**2 Type of change**

Backside of flange with ribs and less material

| Product Change Notification |               |              |             |                 | PCN 1621 |        |             |

**3 Detailed description of change**

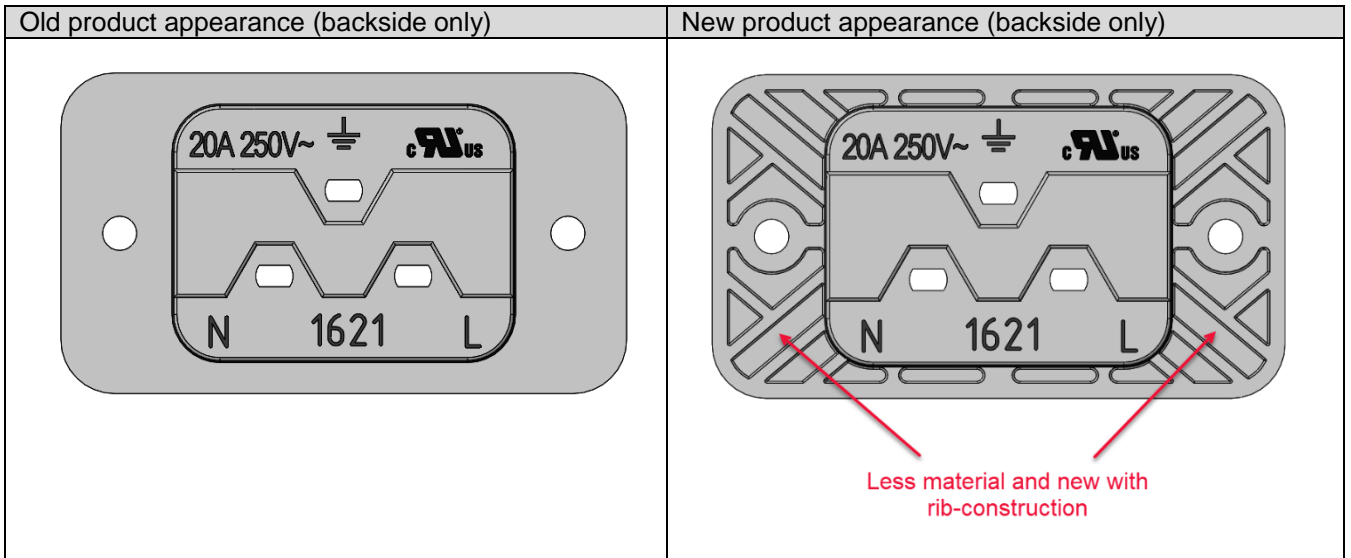
To improve the moulding process and to avoid flow lines

| Form          | Yes | Less material and new a rib construction on the backside of flange |
